# Memorandum

Subject: Preliminary Bedload Sediment Budget for Salinas and Estrella Rivers

Pehl Mine Conditional Use Permit, DRC2005-00027

Figure 1: Geomorphic subreaches of the main stem of the Salinas River near Paso Robles. Note that Estrella River is included in subreach S-1. (Map from Smeltzer, April 30, 2009 Draft Area-Wide Adaptive Management Plan).

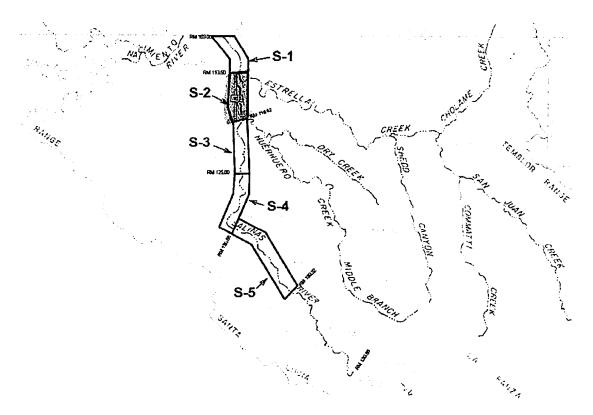
For the purpose of this long-term bedload sediment budget, the upper Salinas River near Paso Robles has been subdivided into five subreaches, Figure 1. The boundaries of these subreaches are somewhat arbitrary, but are intended to capture the potential impacts of the current and proposed in-stream mines and the introduction of additional sediment from major tributaries. The boundaries for the two most downstream these subreaches are defined where the Huerhuero Creek and Estrella River tributaries discharge into the Salinas River. This way the impact of a large additional sediment load can be evaluated. Table 1 describes the five subreaches and lists the total drainage area upstream from the downstream end of the subreach. The Salinas River drainage area for subreach S-1 includes 52 square miles of Vineyard Creek, a tributary that discharges below the confluence of the Estrella River. Table 2 lists the mines in the upper Salinas River area and provides the location on the Salinas River, the permitted extraction volume, whether the mine is in-stream, and the status of the mine.
